# ORIGINATION FORM

Proposed Revisions to a Standard Plans Index  
(Please provide all information – Incomplete forms will be returned)

Index Number: **649-020**  
Sheet Number (s): 1 & 3  
Index Title: Steel CCTV Pole

Sheet 1: Changed Note 2; Note 3 E Delete "ASTM F2329 galvanizing and add "ASTM A36" plate washers; Note 3J add "including plate washers"; Changed Note 4.  
Sheet 3: ELEVATION correct longitudinal bar callout, add reference to Table; Add cross reference to tables on Sheet 2.

LAST REVISION 11/01/17	REVISION	DESCRIPTION:	 FY 2018-19 STANDARD PLANS	STEEL CCTV POLE	INDEX 649-020	SHEET 1 of 6
---------------------------	----------	--------------	--	-----------------	------------------	-----------------

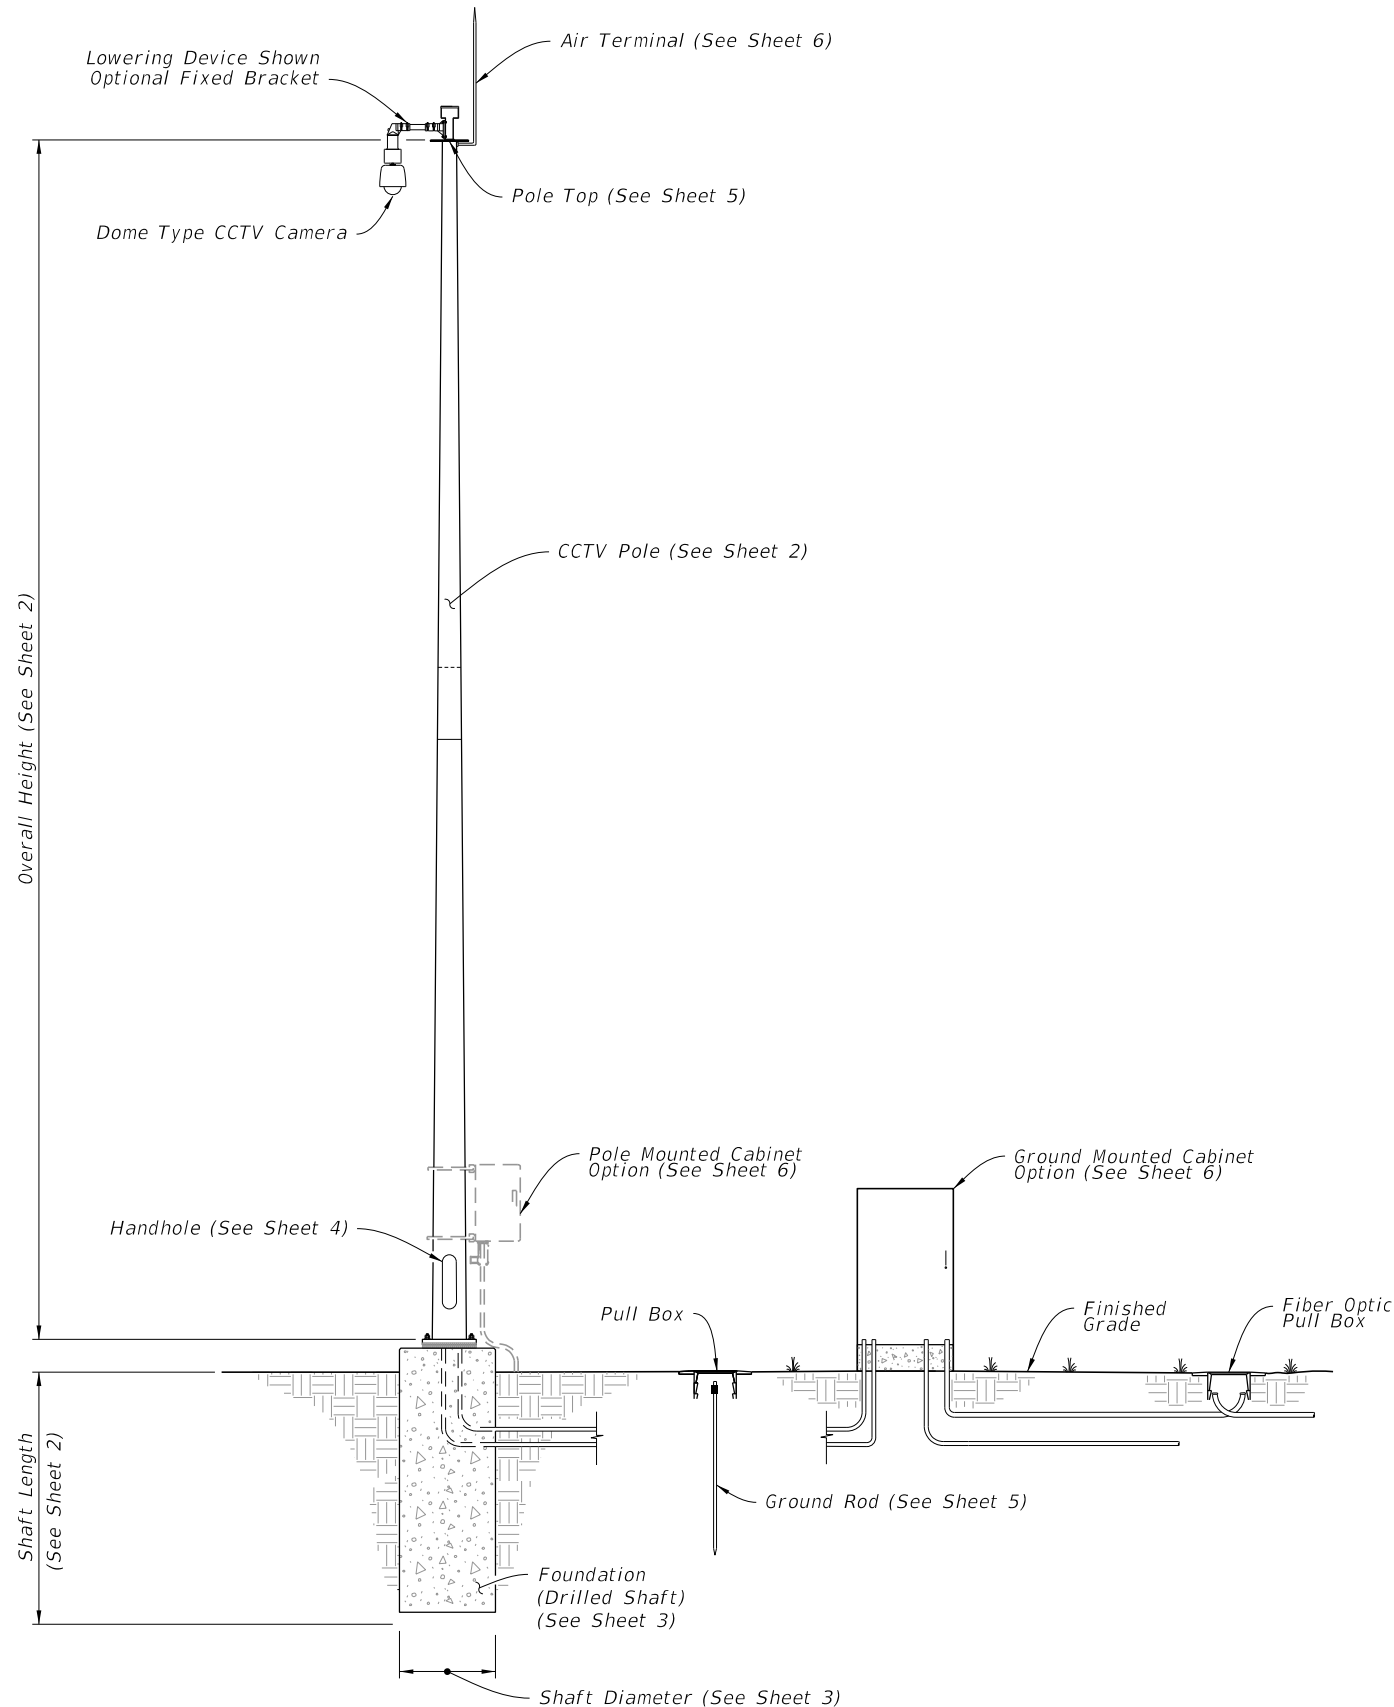
As part of consistency and clarity. Washers for standard bolts with nuts and plate washers require different galvanizing. All longitudinal bars are #11, the number and length vary (table on sheet 2).

Changed Note

- E. Anchor Bolts: ASTM F1554 Grade 55 with ASTM A563 Grade A heavy-hex nuts and ASTM A36 plate washers.
  - F. Handhole Frame: ASTM A709 Grade 36 or ASTM A36.

- G. Handhole Cover: ASTM A1011 Grade 50, 55, 60 or 65.
  - H. Stainless Steel Screws: AISI Type 316.
  - I. Reinforcing Steel: ASTM A615 Grade 60.
  - J. Galvanization: Bolts, nuts and washers: ASTM F2329 All other steel including plate washer: ASTM A123

- K. Concrete: Class IV (Drilled Shaft) for all environment classifications.
4. Fabrication:
  - A. Welding:
    - a. Specification Section 460-6.4 and
    - b. AASHTO RFD Specification for Structural Supports for Highway Signs, Luminaires, and Traffic Signals Section 14.4.4.

- B. Poles:
    - a. Round or 16-sided (Min.)
    - b. Taper pole diameter at 0.14 inches per foot
    - c. Fabricate Pole longitudinal seam welds (2 maximum) with 60 percent minimum penetration or fusion welds except as follows:

1. Use a full-penetration groove weld within 6 inches of the circumferential tube-to-plate connection and
      2. Use full-penetration groove welds on the female end section of telescopic (i.e., slip type) field splices for a minimum length of one and one-half times the inside diameter of the female section plus 6 inches.

**FOUNDATION**

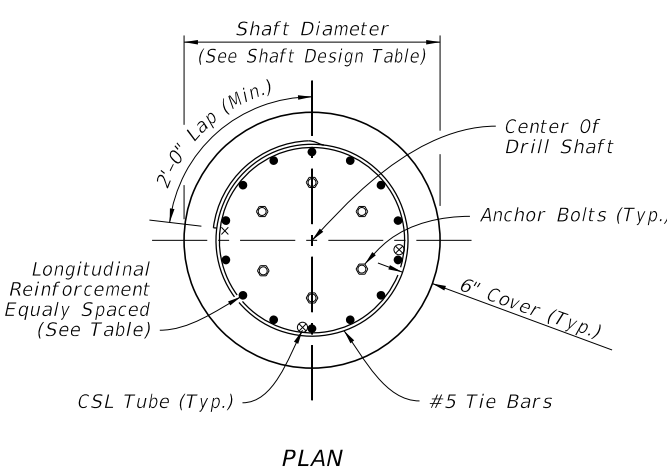
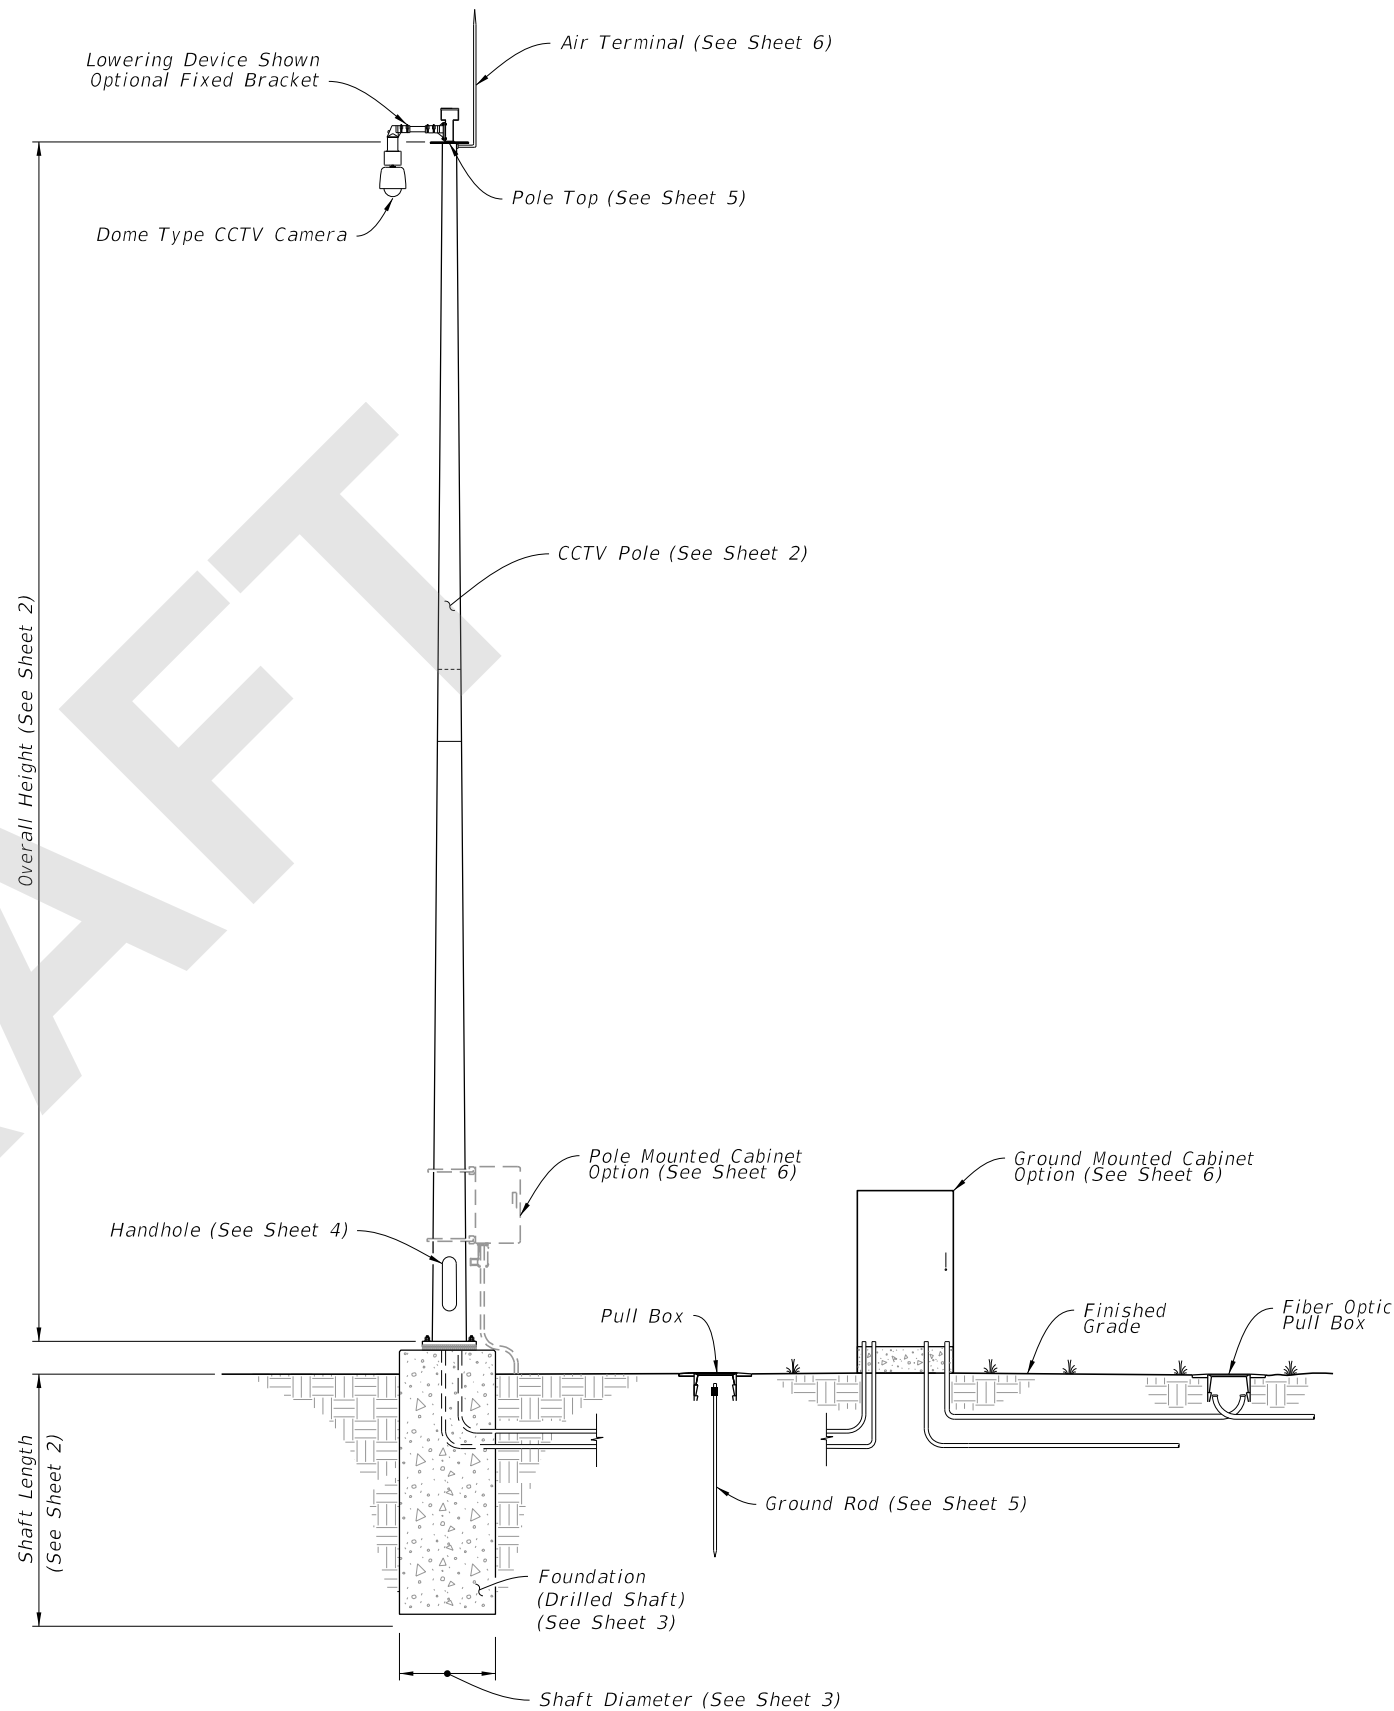
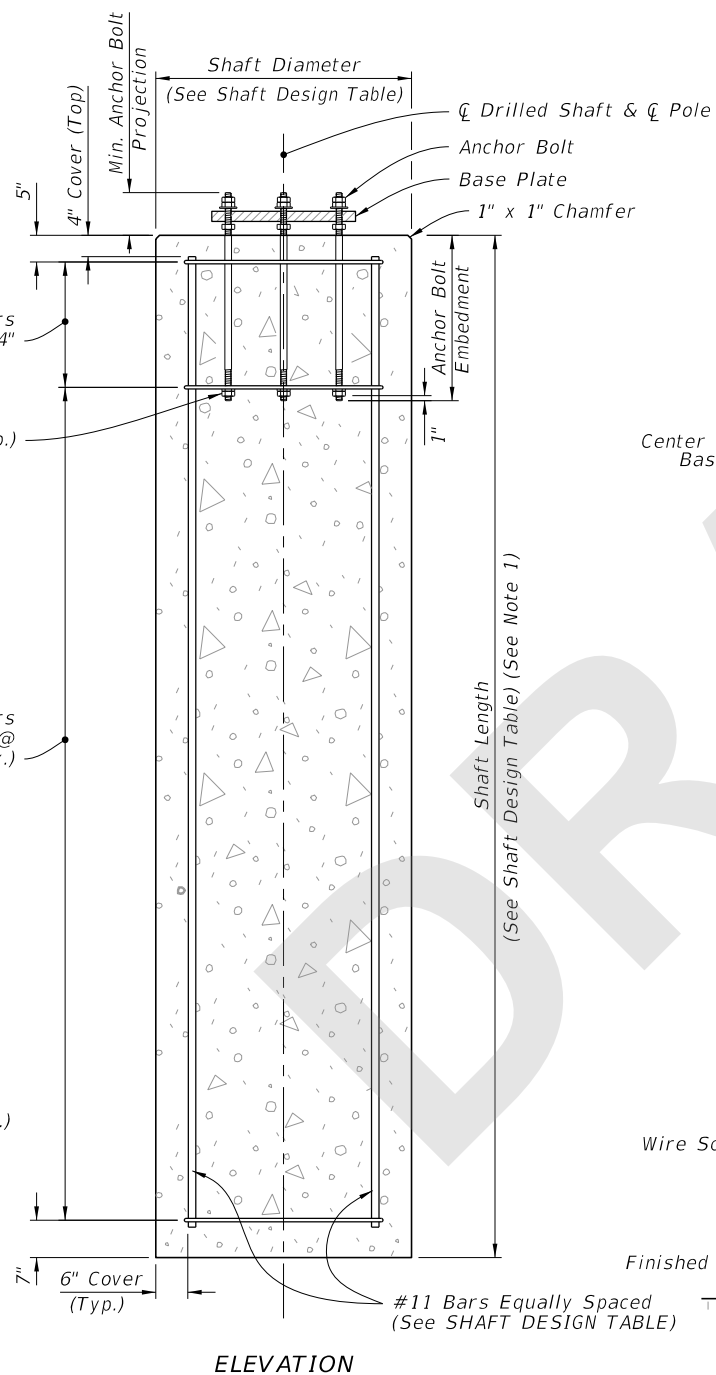
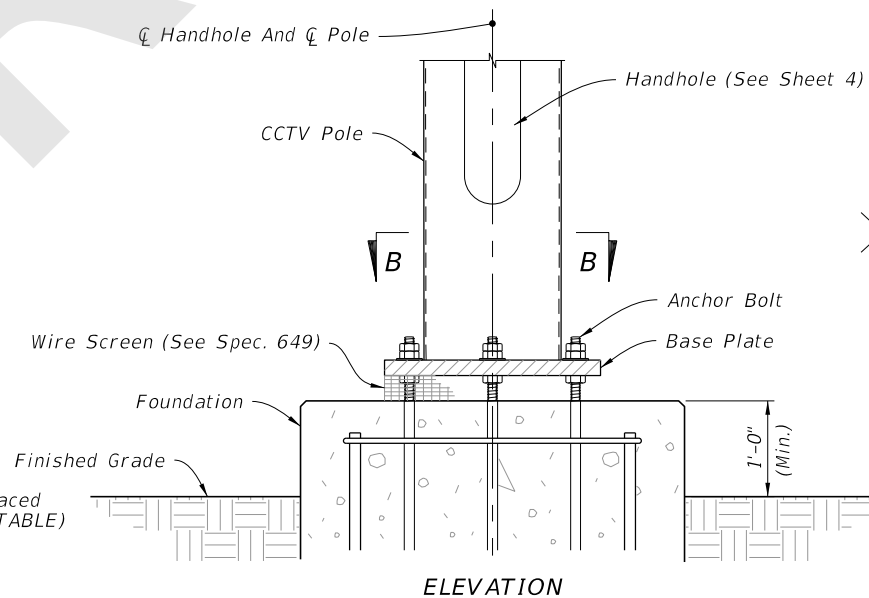
Cross Reference

# ? Bars Equally Spaced

1. Shaft Length is based on 1'-0" height above the finished grade.
2. Double nuts: Bottom nut may be half height 'Jam' Nut. Provide individual nut covers (Not Shown) for each bolt.
3. Conduit and CSL Tubes not shown for clarity.
4. Work these details with Data Table on Sheet 2.
